Access Compliance Report

Public Rights-of-Way

(Curb Ramps)

Intersection ID: 15070	Main Street: IDEAL_WY	Cross Street: REMOUNT_RD	Location:	N
ADA ID: 38A691E5F849	Ramp Type: Perp	Initial Pass/Fail: Fail	Overall Compliance: No	Severity Score: 21.25
Codes/Mitigation Info/Possible Solution		Field Measurements/Component Compliance

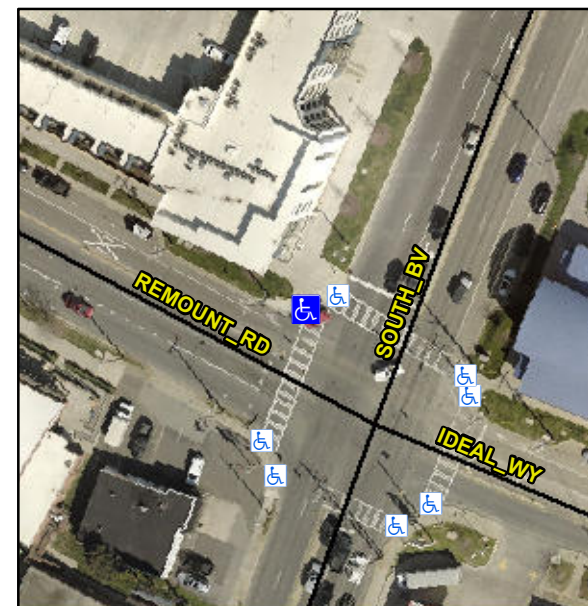
Not Found, R304.5.1, R304.2.2

Compliance	Description	Data	Compliance	Description	Data
N/A	Ramp Length (in)	71.0	No	Ramp Slope (%)	8.9
No	Ramp Width (in)	42.0	Yes	Ramp XSlope (%)	1.6
N/A	Flare Type LT	N/A	N/A	Flare Type RT	N/A
N/A	Flare Slope LT (%)	N/A	N/A	Flare Slope RT (%)	N/A
N/A	Flare Traversable LT?	N/A	N/A	Flare Traversable RT?	N/A
N/A	Landing Length (in)	N/A	N/A	DWS Provided?	N/A
N/A	Landing Width (in)	N/A	N/A	DWS Contrast?	N/A
N/A	Landing Slope (%)	N/A	N/A	DWS Length (in)	N/A
N/A	Landing X Slope (%)	N/A	N/A	DWS Full Width?	N/A
N/A	Landing Curb? (Y/N)	N/A	N/A	DWS Offset (in)	N/A
N/A	Shared Landing?	N/A			
N/A	Gutter Ponding?	N/A	N/A	Gutter Slope (%)	N/A
N/A	Gutter Lip Ht (in)	N/A	N/A	Gutter X Slope (%)	N/A
N/A	Painted X Walk1?	Yes	N/A	Painted X Walk2?	N/A
	X Walk 1 Direction	To SW		X Walk 2 Direction	N/A
N/A	X Walk 1 Width (in)	118.0	N/A	X Walk 2 Width (in)	N/A
	X Walk 1 Slope (%)	0.5		X Walk 2 Slope (%)	N/A
	X Walk 1 X Slope (%)	1.6		X Walk 2 X Slope (%)	N/A

Remove & Replace Entire Ramp.
